SERVICE BULLETIN: NEW EVFPK

EFFECTIVE: 01/01/2025

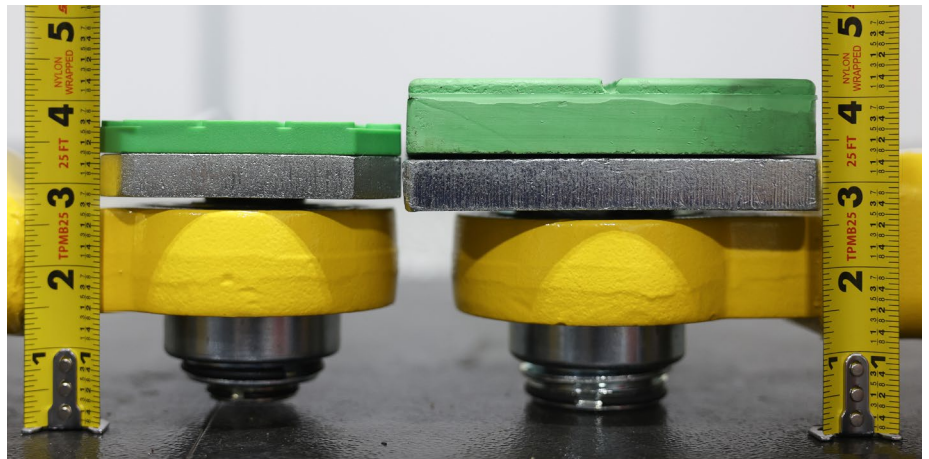
Effective immediately, there will be a change in the design of the footpad kit used for electric vehicle service. The current footpad kit (TFPK) will be replaced with new P/N EVFPK. This change was implemented to aid technicians in quickly spotting and raising electric vehicles. The new EVFPK is ALI® certified with all of our 10K and 12K 2-Post and Inground lifts.

The TFPK was, in some cases, too tall to fit under vehicles and too long to fit in a particular pick-up point location.

- Lower than current TFPK
- Double screw-up for finer adjustments
- Fits in smaller spaces
- Pad is more durable and thinner
